City Planning Commission Meeting – April 28, 2015

CONSIDERATION – SUBDIVISION DOCKET – 023/15

Applicant: Theodore W. Nass, III

Proposal: Subdivision of Lot 11-A into Lots 11-A-1 and 11-A-2.

**RESUBDIVISION OF
LOT 11-A INTO
LOTS 11-A-1 AND 11-A-2
SQUARE 121
BOULIGNY
SIXTH DISTRICT
ORLEANS PARISH, LA**

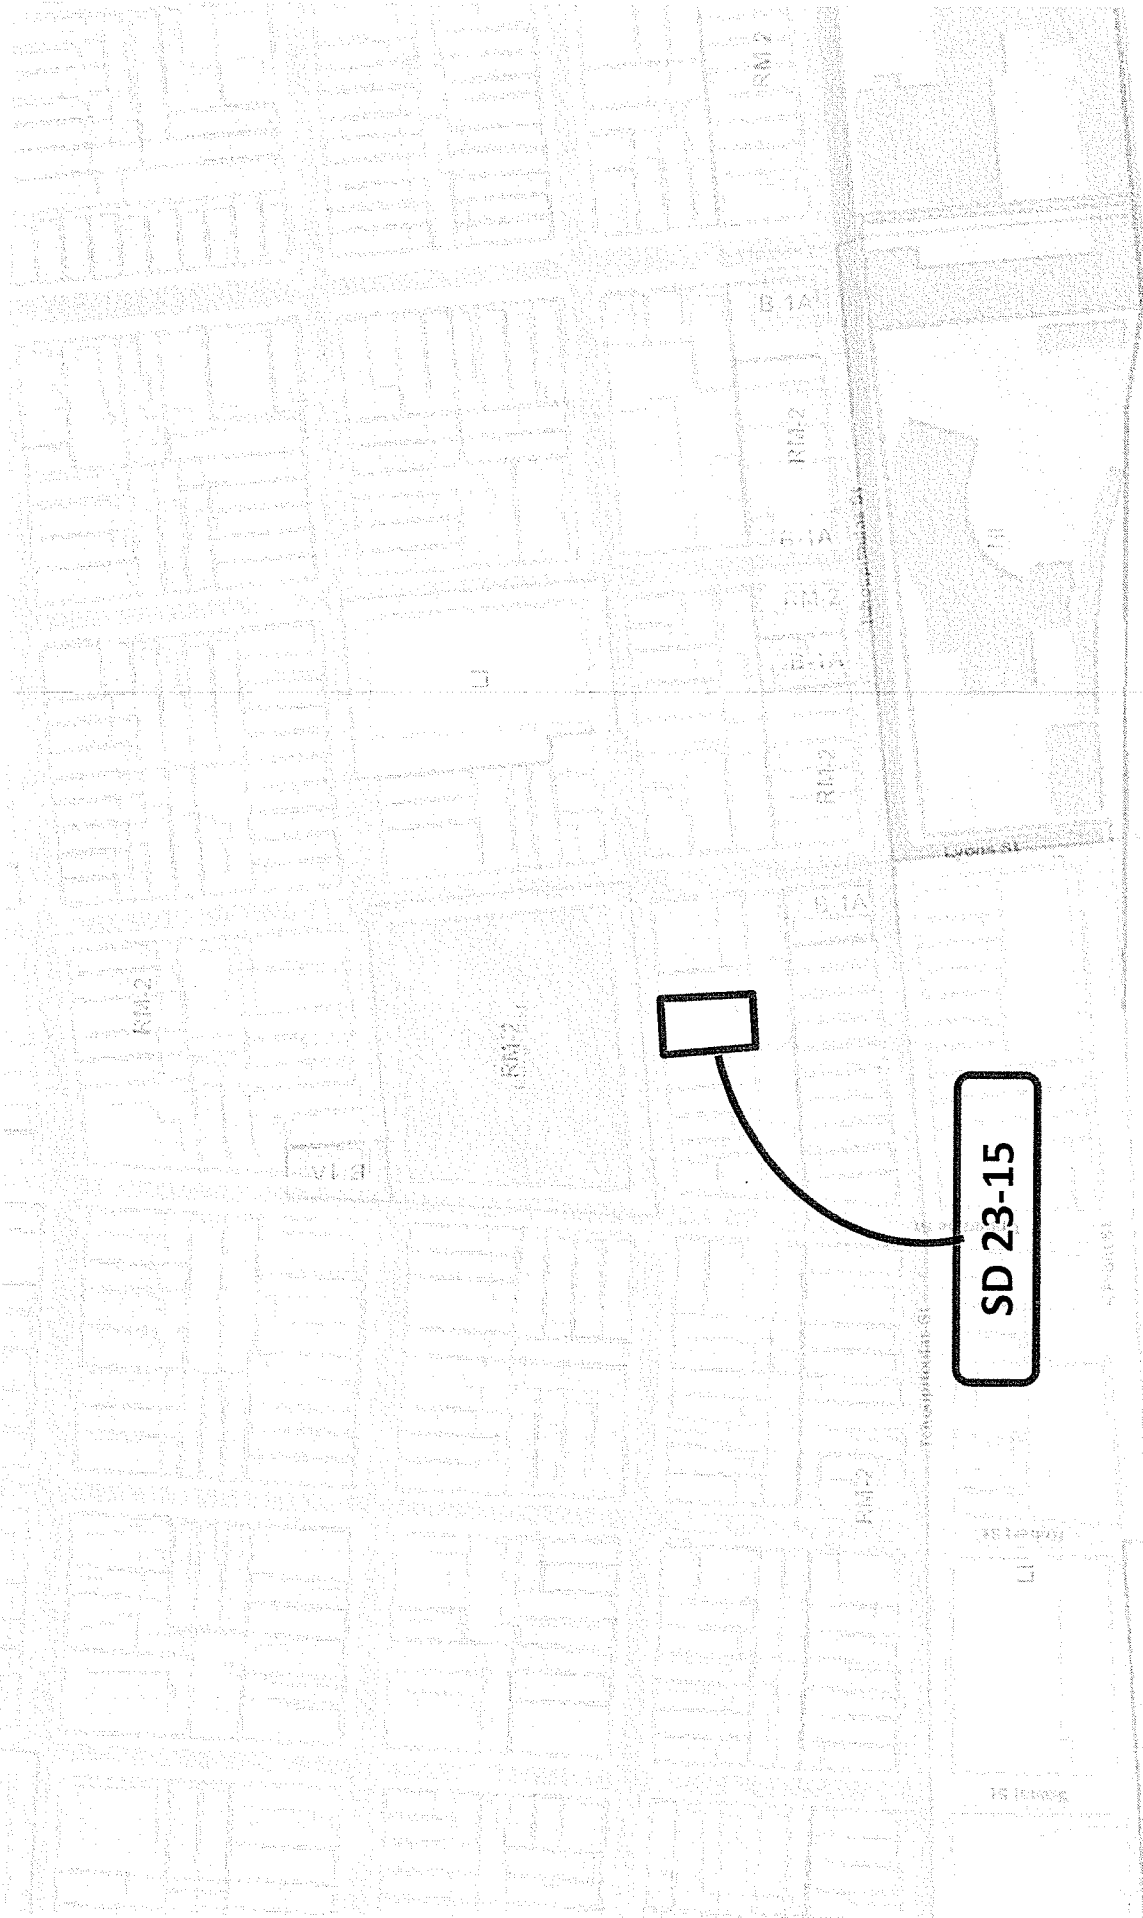
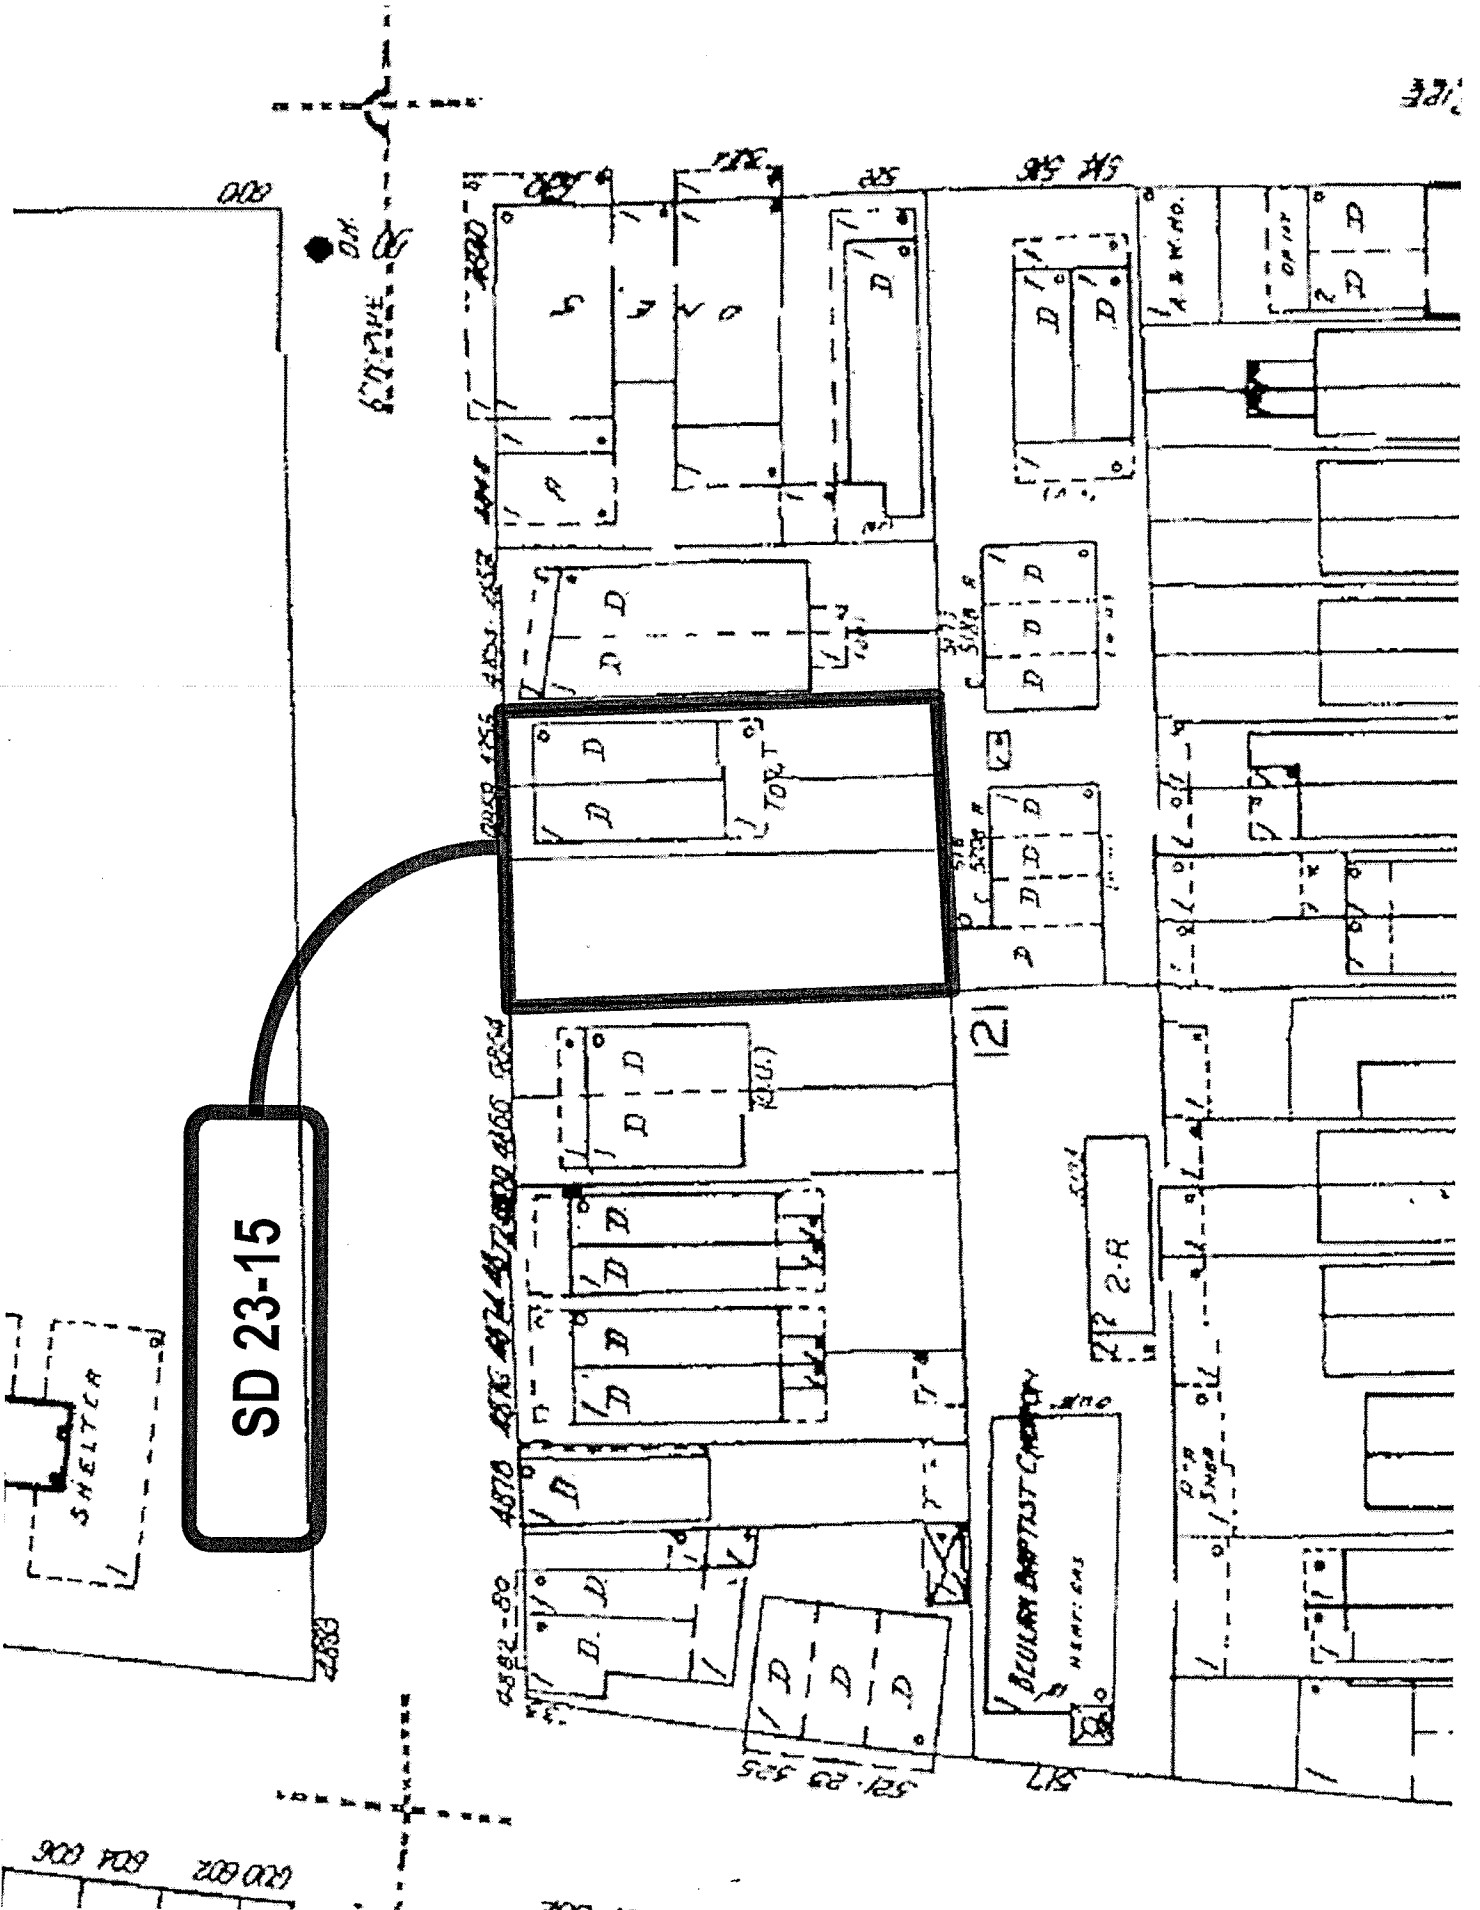
The Department of Property Management, Division of Real Estate and Records noted no objection to the proposal, finding no exceptions regarding ownership, and requested that the old lot number (11-A) be shown on the survey.

The representative of the Sewerage and Water Board stated that sewer and water facilities are available but not shown, and that a note should be shown on the plans stating that sewer and water house connections are the property owner's responsibility. Sewerage and Water Board also stated that subsurface drainage is not available.

The Department of Safety and Permits commented that the shed in the rear of the property needs to be demolished because it crosses the new proposed lot line.

1. The applicant shall apply for and secure a variance from the Board of Zoning Adjustments for insufficient lot area for proposed Lots 11-A-1 and 11-A-2.
2. The applicant shall comply with any requirements deemed necessary by Entergy, the Sewerage and Water Board, the Departments of Public Works, the Department of Property Management, Division of Real Estate and Records, and the Department of Safety and Permits.
3. The applicant shall comply with all other Subdivision Regulations, which includes the submittal of mortgage certificates, a consent letter from the mortgage company (if applicable) and tax certificates for the petitioned site.
